Accessibility Audit Report

Institute of Home Economics

University of Delhi

1.07.2026

Existing

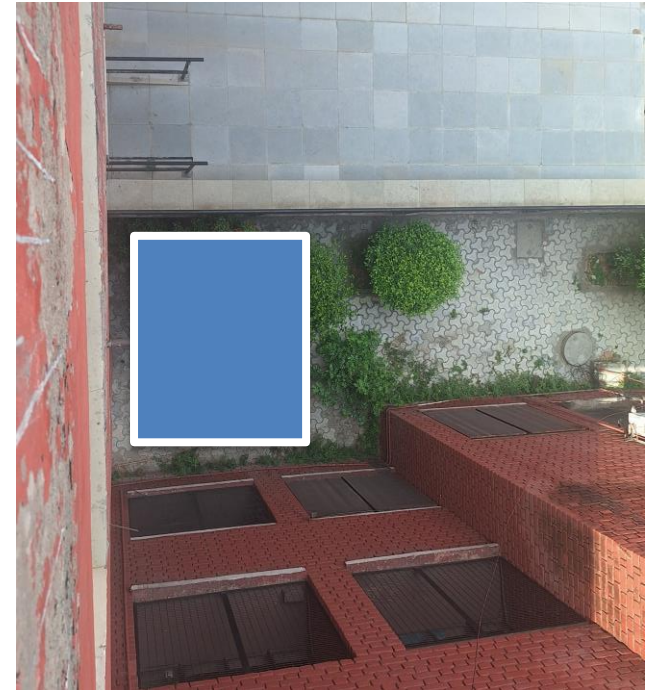
- TGSi warning is missing at the steps (start and end of the steps)
- Ramp shall be provided by replacing the steps on one side.
- **Refer page 34 and 58.**
